**Village Review Response Memorandum:**

**Project: Stonecast Off-Site Storage**

**Comments Received: 1-5-2023**

**Plans Reviewed:**

**NORTH PARTIAL  
 SITE PLAN  
 WITH LANDSCAPING**

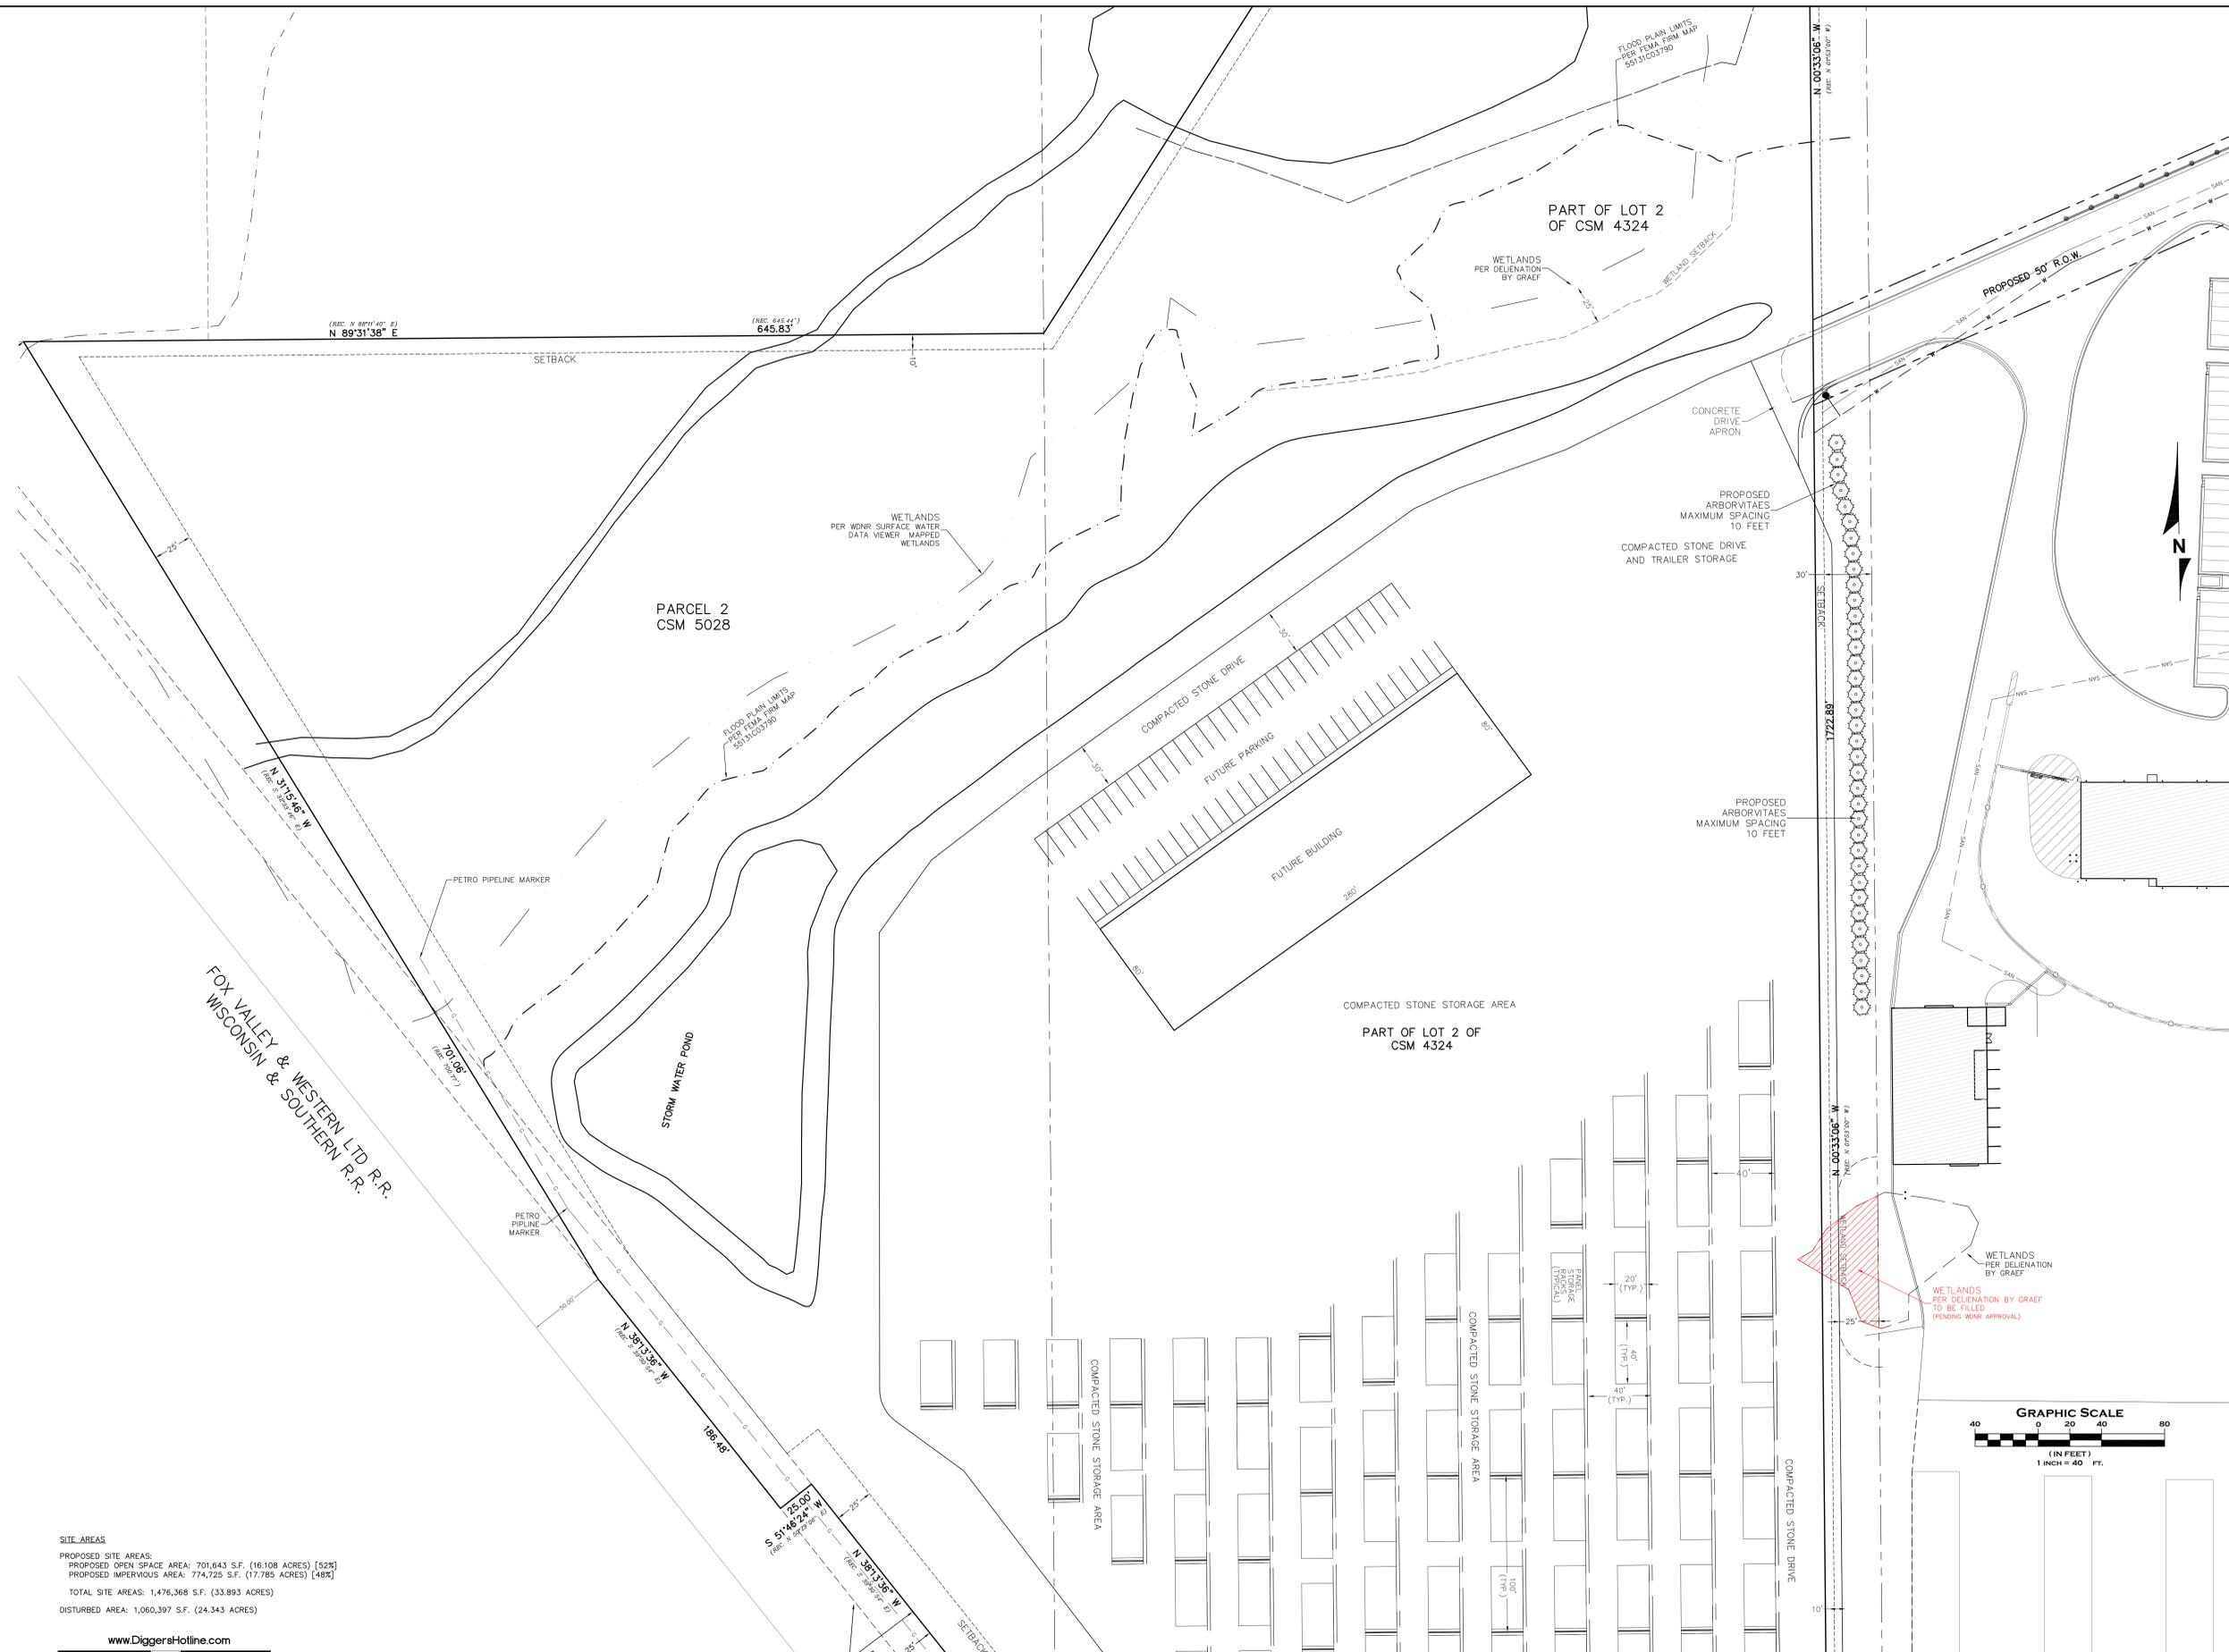
5. As we discussed previously, outdoor storage yards are a permitted use in the M-1 District provided they are "visually screened from public streets or highways and adjacent non-industrial uses". How do you intend to screen the yard along the common property line with the Village's DPW site? Will the existing tree line, in whole or in part, be left intact to accomplish the required screening? If so, provide details about the amount/width and type of tree line that will be retained. If not, provide details on how screening will be provided (along the north-south & east-west common property lines shared with the DPW facility). A detailed landscaping plan is required that specifically shows where trees will be planted on the site, what type, quantity, and size at time of planting. *Response: Landscaped screening elements have been added to the revised site plan.*

**NORTH PARTIAL SITE GRADING PLAN C2.1**

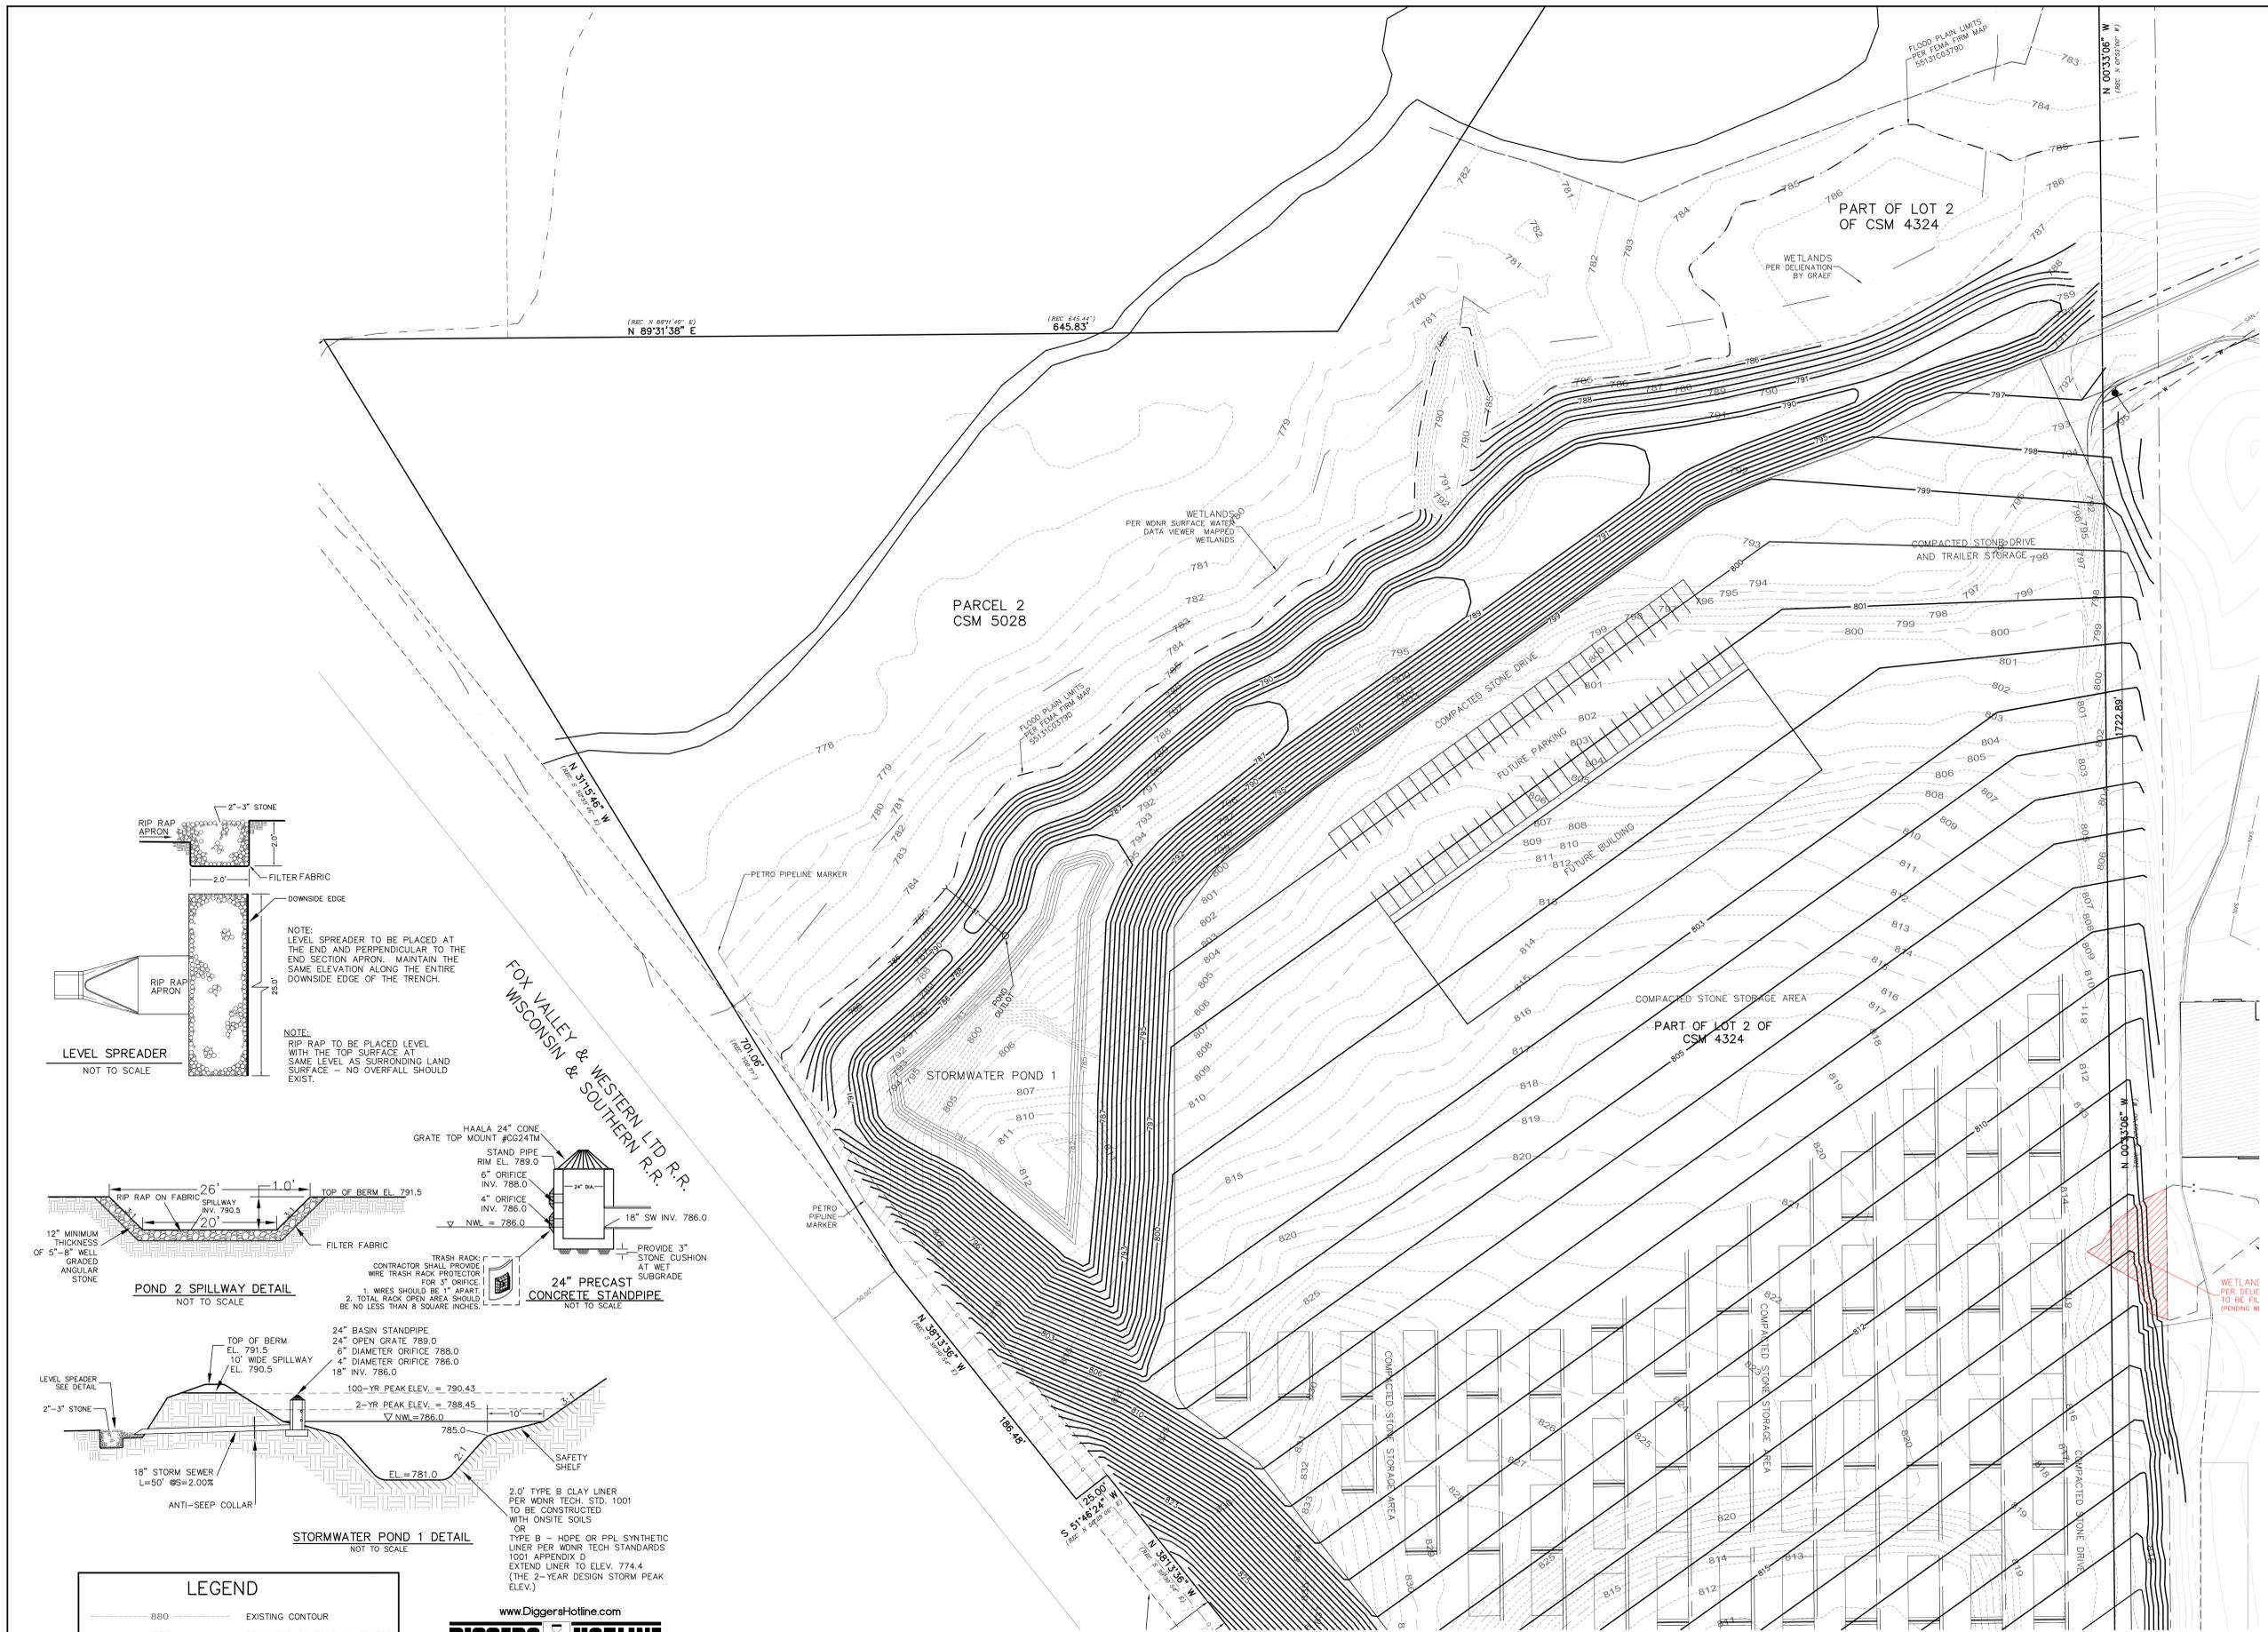
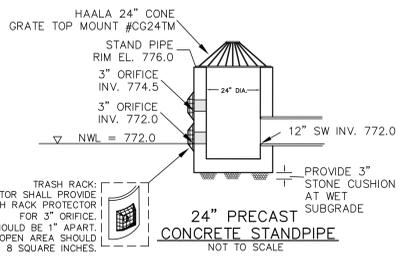
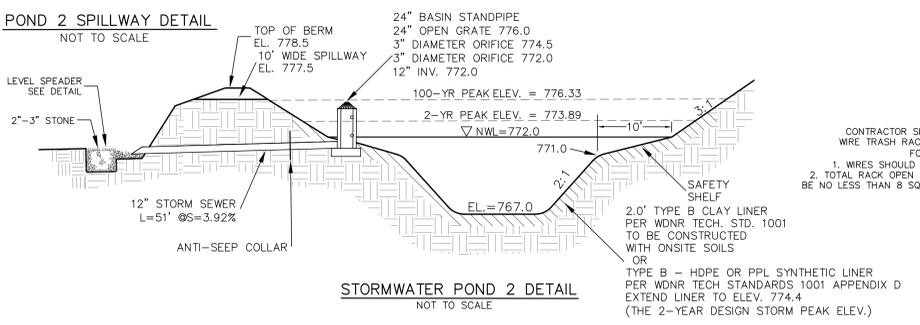
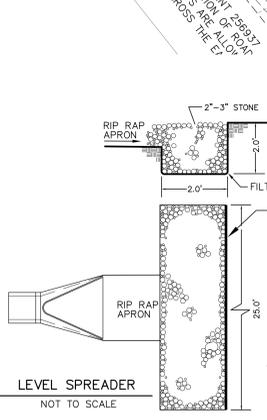
1. Plans propose sheet flowing a large gravel area at 5% slope to a 3:1 slope. Provide calcs showing the 3:1 is stable and will not be an erosion problem. *Response: Calcs have been provided as a separate document that shows Class II Type B erosion matting provides the permissible sheer stress strength for the 100 year storm events.*
2. Provide a trash grate with detail for the outlet orifices. *Response: Trash grate detail has been added to the plans and called off as such for each outlet orifice as requested.*
3. Provide a level spreader with detail at the pond outlets. *Response: Level spreader and detail have been added to the plans as requested.*
